Document: T10/01-230r0
 To: T10 Committee Membership
 From: Edward A. Gardner, Ophidian Designs
 Subject: SRP Buffer Descriptor Subclause Rewrite

Date: 18 July 2001

Figure 3 - Indirect data buffer mapping without cached memory descriptors

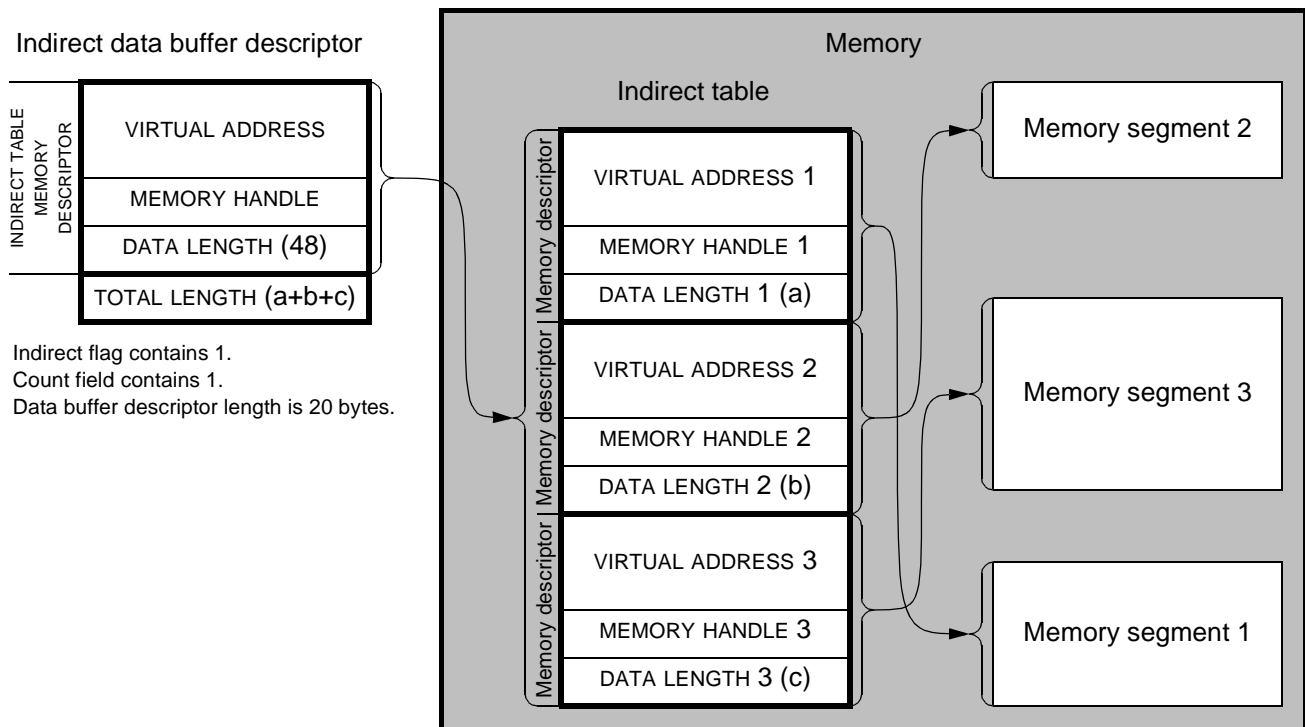
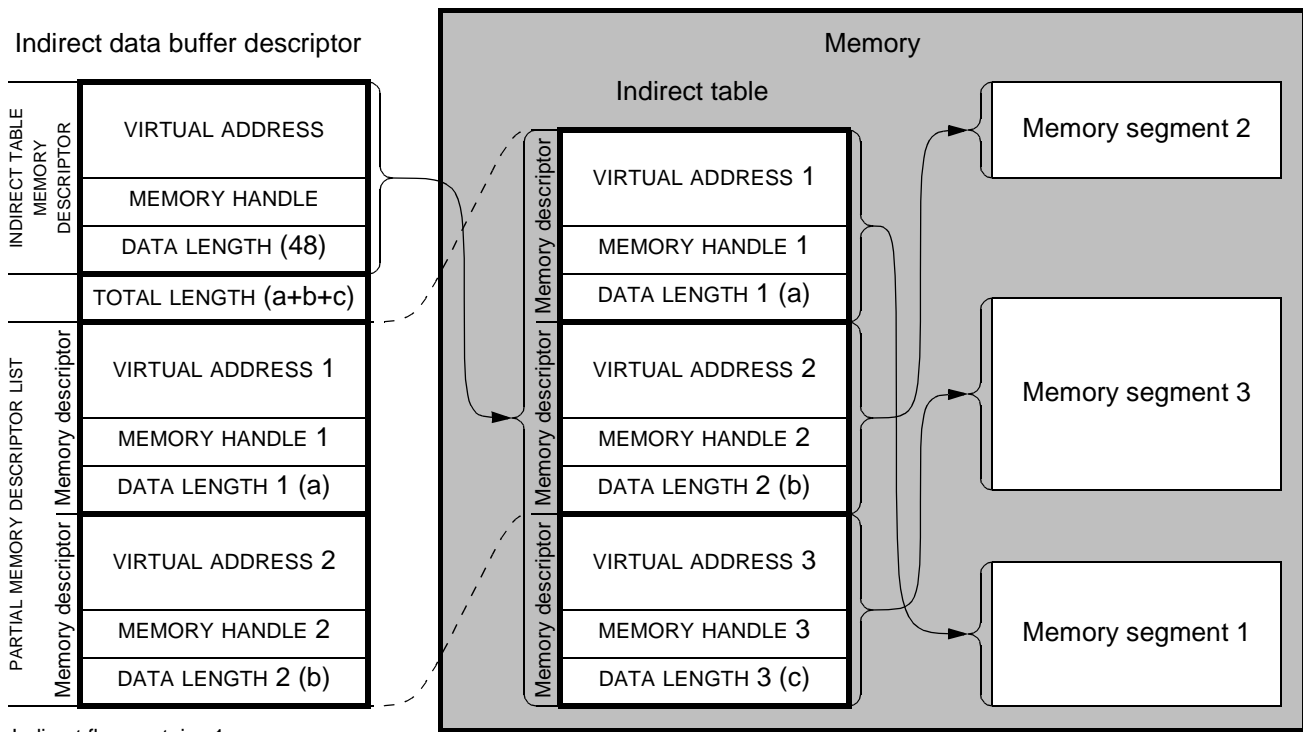
Figure 3 illustrates an indirect data buffer without a PARTIAL MEMORY DESCRIPTOR LIST. Memory is shown containing four memory segments: the indirect table, memory segment 1, memory segment 2 and memory segment 3. The mapping of each memory descriptor to its memory segment has been shown as a single arrow. For details of this mapping see 4.4.1 and figure 2. Figure 3 does not show the memory regions in which the memory segments reside. All four segments might be in a single memory region, each might be in a separate memory region, or several might be in one memory region and the remainder in one or more other memory regions.

In this example the indirect flag is 1 and the count field is 1. The data buffer descriptor is 20 bytes long. The data buffer is comprised of three memory segments: memory segment 1, memory segment 2 and memory segment 3. A separate memory segment contains the indirect table, a list of three memory descriptors identifying memory segments 1 through 3. The INDIRECT TABLE MEMORY DESCRIPTOR field of the data buffer descriptor identifies the memory segment containing the indirect table. The DATA LENGTH field of INDIRECT TABLE MEMORY DESCRIPTOR would contain 48, the length of the indirect table. The TOTAL LENGTH field of the data buffer descriptor would contain the sum of the DATA LENGTH fields of the memory descriptors in the indirect table (the sum of DATA LENGTH 1, DATA LENGTH 2 and DATA LENGTH 3). This sum is the total length of the data buffer.
